**GEOTECHNICAL REPLY TO PEER REVIEW,  
PRELIMINARY CITY STORM DRAIN OUTFALL  
SLOPE RETREAT ASSESSMENT,  
& GEOTECHNICAL REPORT UPDATE STUDY**  
Proposed Glenview Terrace Residential Subdivision  
2880 San Bruno Avenue  
San Bruno, California

**RE: GEOTECHNICAL REPLY TO PEER REVIEW,  
PRELIMINARY CITY STORM DRAIN OUTFALL  
SLOPE RETREAT ASSESSMENT,  
& GEOTECHNICAL REPORT UPDATE STUDY**  
Proposed Glenview Terrace Residential Subdivision  
2880 San Bruno Avenue  
San Bruno, California  
GEO #91-04747-A (2172)

The following section presents our reply to comments delivered in a December 20, 2019, 6-page Geologic and Geotechnical Peer Review letter prepared by Geocon, Inc. (GC, Project No. E9138-04001)

Job No.: 91-04747-A	<b>SLOPE STABILITY LINE OF CROSS SECTIONS PLAN</b> Glenview Terrace Residential Development 2880 San Bruno Avenue San Bruno, California	<b>Plate G6</b>
	Approved: JEB		
	Date: 01.27.2020

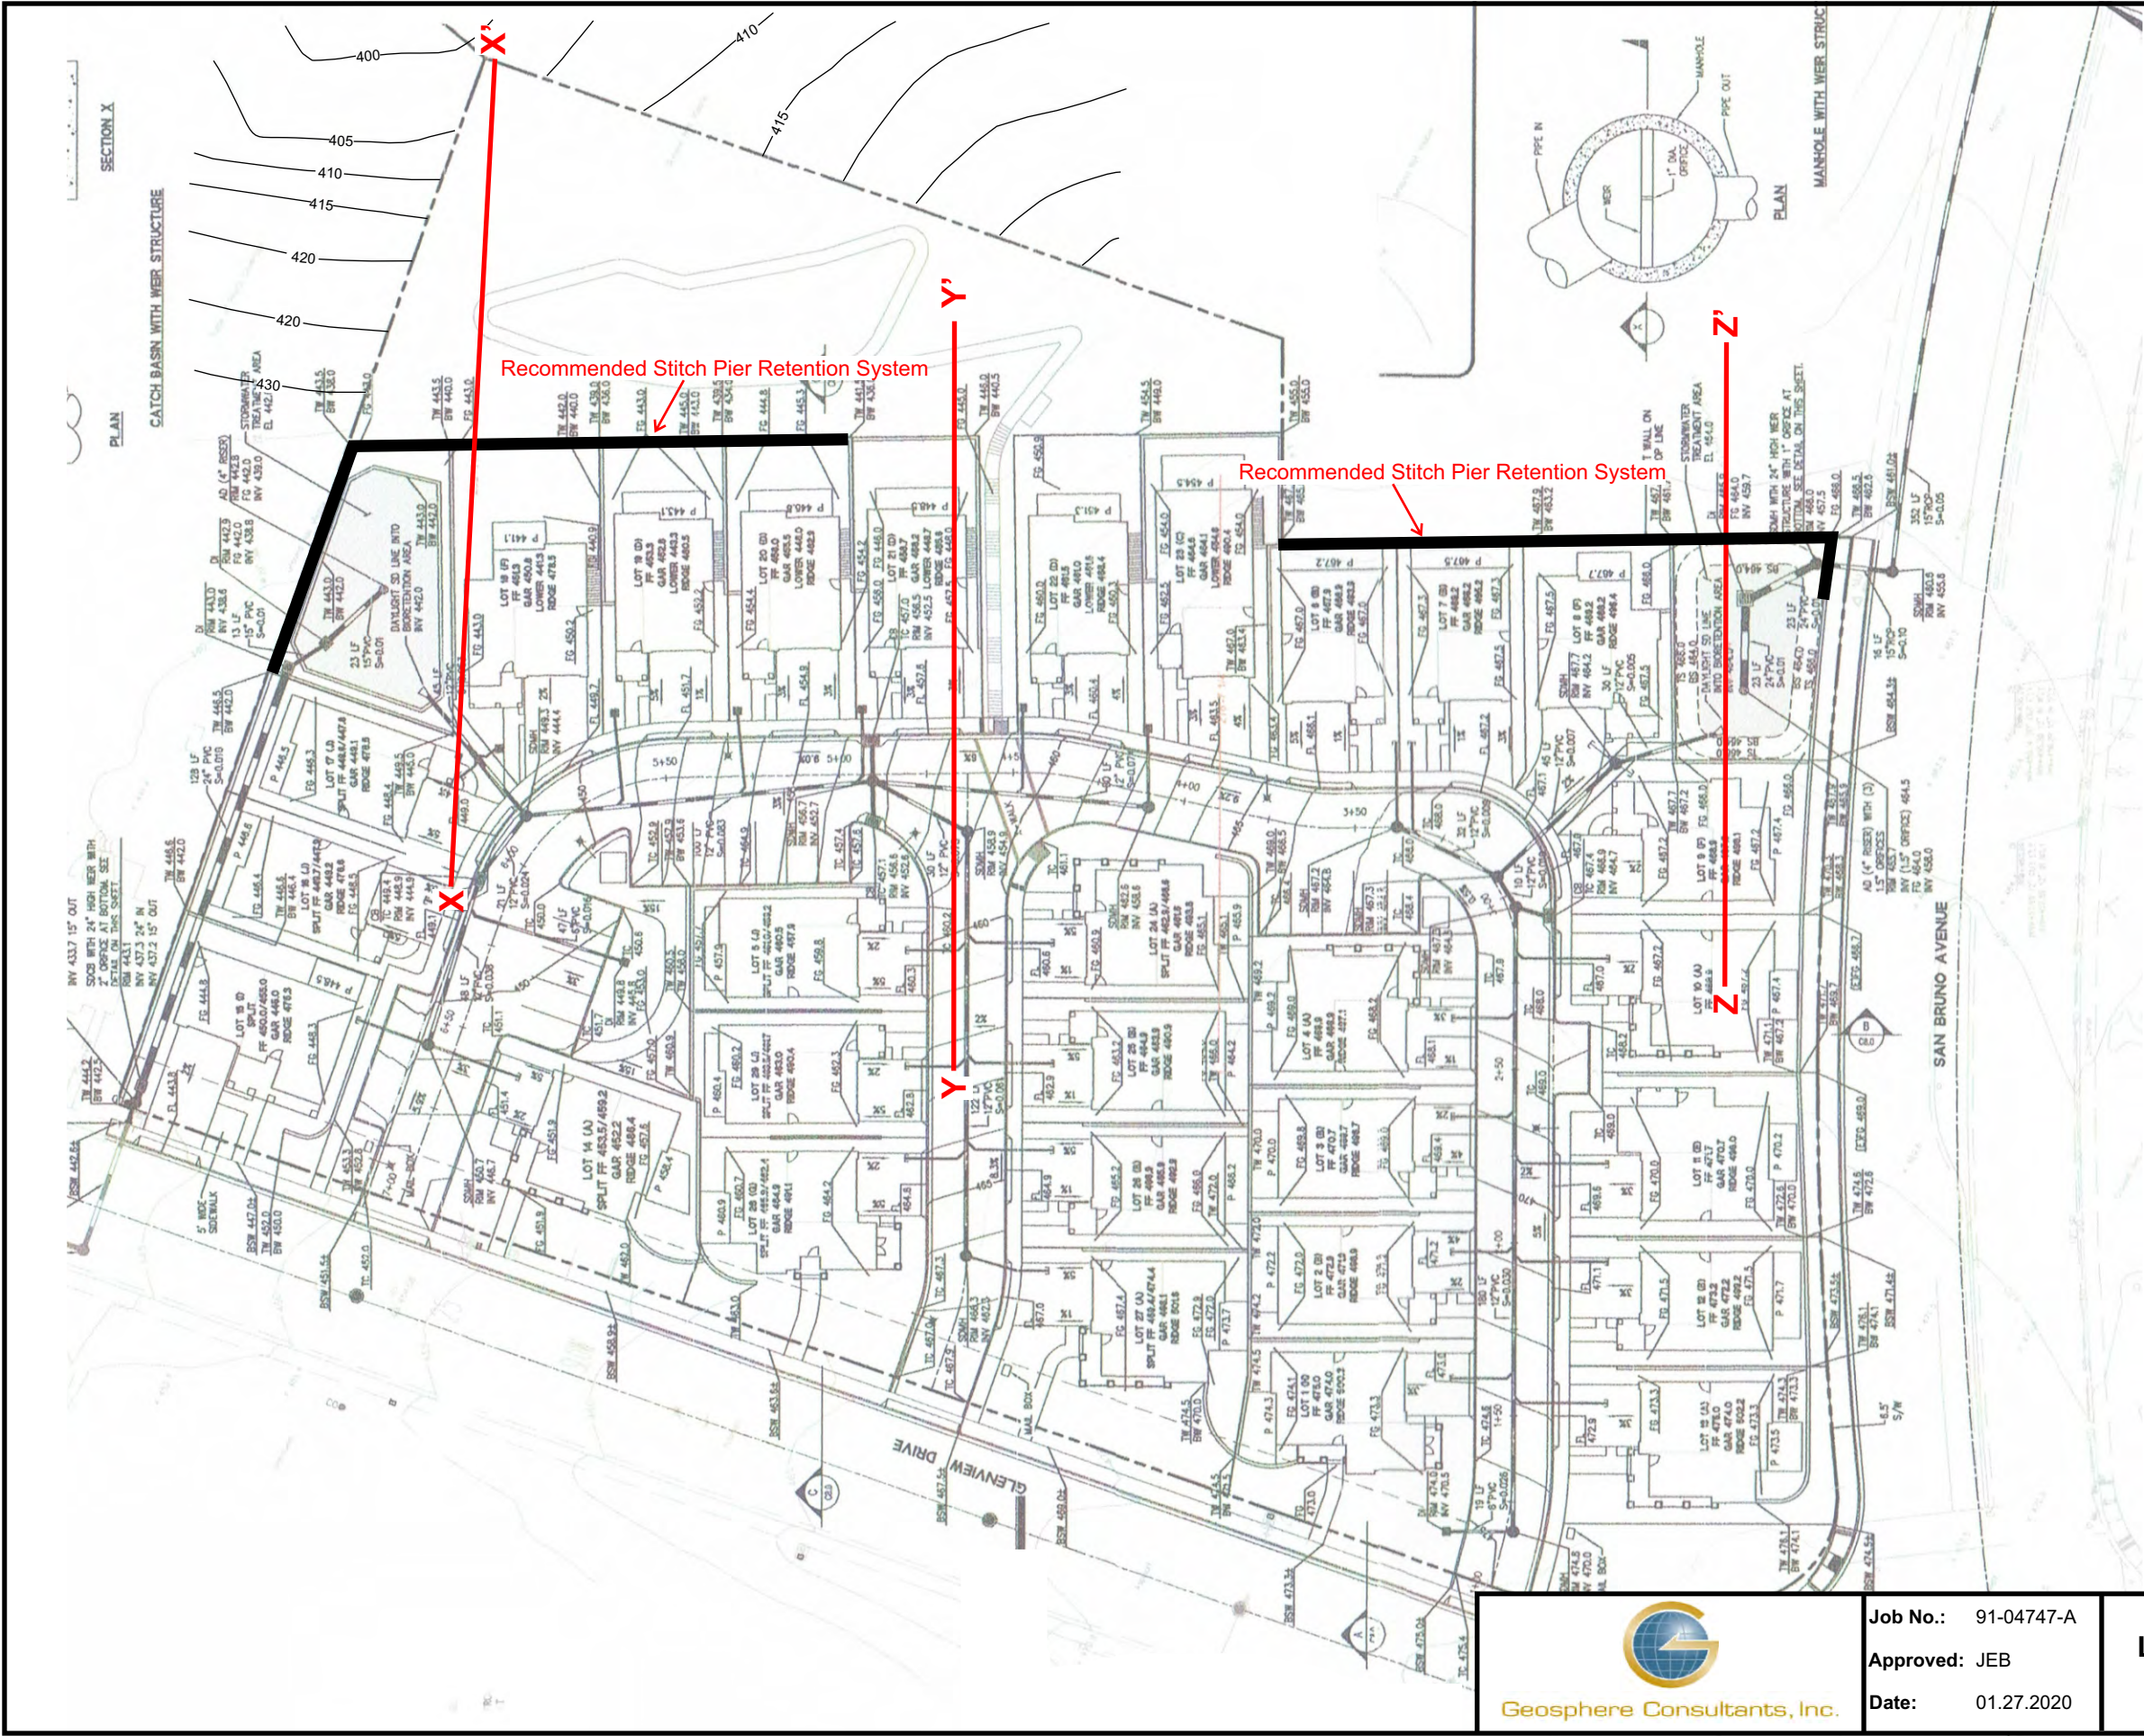
Static and seismic stability was characterized for three (3) critical slope segments on the eastern side of the project area (Plate G6, Slope Stability Line of Cross Sections Plan). The sections are graphically represented on the respective computer printouts (Plates G7 through G18). The stability analyses input data is based upon the project topographic site plan prepared by BKF Civil Engineers (dated August 8, 2016), and the relatively large volume of subsurface soil profile data compiled over the past decade by Earth Investigations Consultants (2006, 2008, 2013, 2016), and recently by Geosphere (2019). The following sections of this appendix discuss material strength parameters, seismic coefficient, ground water conditions, model description, and slope stability analyses results.

The results of the stability analyses, as summarized in Appendix G, show that under existing site conditions under static loading, the eastern slope had computed Factors of Safety (FoS) ranging from 1.4 to 3.9 between the north and south ends of the property, respectively. The lower (1.4) value was obtained at the location of Cross Section X-X'; however, this value represented the area downslope of the existing residence, outside of the limits of the proposed development property. Theoretical failure surfaces intersecting within the limits of the property all had FoS exceeding 1.5. Under design event seismic loading, FoS ranged between 0.7 and 1.3, suggesting that current stability of the northern half of the eastern slope may be marginal under seismic loading conditions, with seismic FoS values under 1.1 calculated at both Sections X-X' and Y-Y'.
